## 7.0 Instrumentation and Control Systems

The information in this section of the reference ABWR DCD, including all subsections and tables, and figures, is incorporated by reference with the following departures and supplements.

**Figure 7.1-1 SSLC Self-Test System**

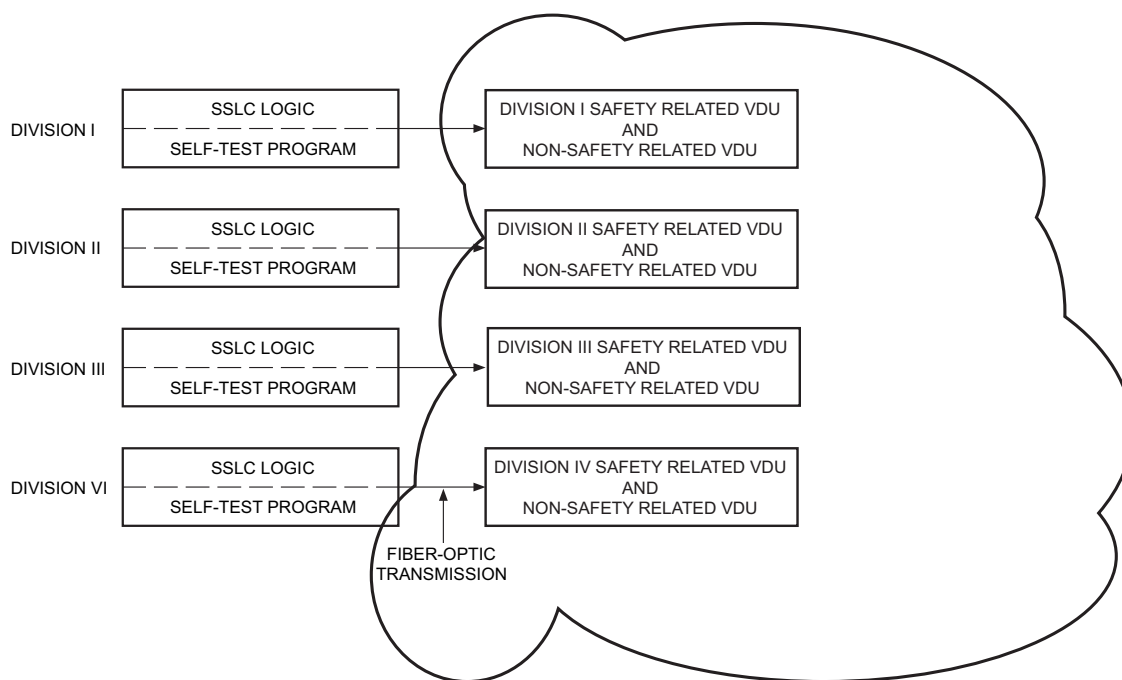
STD DEP T1 3.4-1 (Figure 7.1-1, 7.1-2)

STD DEP T1 3.4-1

*The RPS and ESF Systems can be tested during reactor operation by six separate tests. The first five tests are primarily manual tests and, although each individually is a partial test, combined with the sixth test they constitute a complete system test. The sixth test is the self-test of the safety system logic and control which automatically tests the complete system excluding sensors and actuators.*

Figure 7.1-2 Assignment of Interfacing Safety System Logic to SSLC Controllers

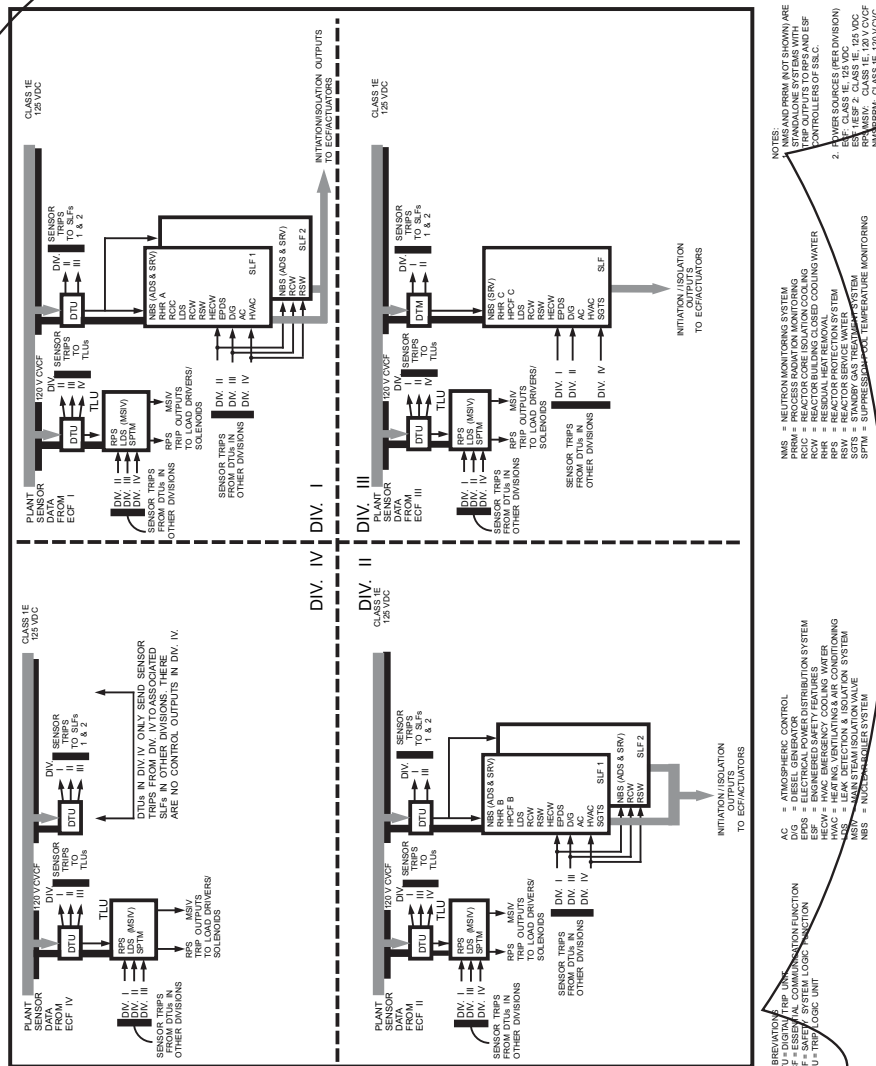
*Divisional separation is also applied to the ~~essential multiplexing system (EMS)~~ Essential Communication Function (ECF) for Safety System Logic and Control (SSLC), which provides data highways for the sensor input to the logic units and for the logic output to the system actuators (actuated devices such as pump motors and motor-operated valves). Systems which utilize the SSLC are: (1) Reactor Protection (trip) System; (2) High Pressure Core Flooder System; (3) Residual Heat Removal System; (4) Automatic Depressurization System; (5) Leak Detection and Isolation System; (6) Suppression Pool Monitoring System; and (7) Reactor Core Isolation Cooling System. The equipment arrangement for these systems and other supporting systems is shown in Figure 7.1-2.*
